Access Compliance Report

Public Rights-of-Way

(Curb Ramps)

Intersection ID: 28162	Main Street: BLAKENEY_HEATH_RD	Cross Street: KNIGHTSDALE_DR	Location:	N
ADA ID: E127911FC82D	Ramp Type: PerpDiag	Initial Pass/Fail: Fail	Overall Compliance: No	Severity Score: 25

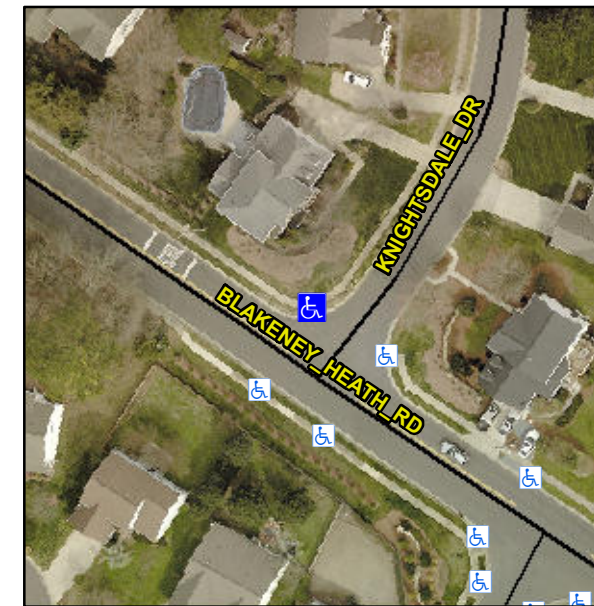
Not Found, R304.5.3

Compliance	Description	Data	Compliance	Description	Data
N/A	Ramp Length (in)	68.0	Yes	Ramp Slope (%)	5.3
Yes	Ramp Width (in)	48.0	No	Ramp XSlope (%)	8.6
N/A	Flare Type LT	N/A	N/A	Flare Type RT	N/A
N/A	Flare Slope LT (%)	N/A	N/A	Flare Slope RT (%)	N/A
N/A	Flare Traversable LT?	N/A	N/A	Flare Traversable RT?	N/A
N/A	Landing Length (in)	N/A	N/A	DWS Provided?	N/A
N/A	Landing Width (in)	N/A	N/A	DWS Contrast?	N/A
N/A	Landing Slope (%)	N/A	N/A	DWS Length (in)	N/A
N/A	Landing X Slope (%)	N/A	N/A	DWS Full Width?	N/A
N/A	Landing Curb? (Y/N)	N/A	N/A	DWS Offset (in)	N/A
N/A	Shared Landing?	N/A			
N/A	Gutter Ponding?	N/A	N/A	Gutter Slope (%)	N/A
N/A	Gutter Lip Ht (in)	N/A	N/A	Gutter X Slope (%)	N/A
N/A	Painted X Walk1?	No	N/A	Painted X Walk2?	No
	X Walk 1 Direction	To SW		X Walk 2 Direction	To SE
N/A	X Walk 1 Width (in)	N/A	N/A	X Walk 2 Width (in)	N/A
	X Walk 1 Slope (%)	4.5		X Walk 2 Slope (%)	2.1
	X Walk 1 X Slope (%)	3.8		X Walk 2 X Slope (%)	3.2

Remove & Replace Curb Ramp With Two New Directional Ramps or Equivalent.
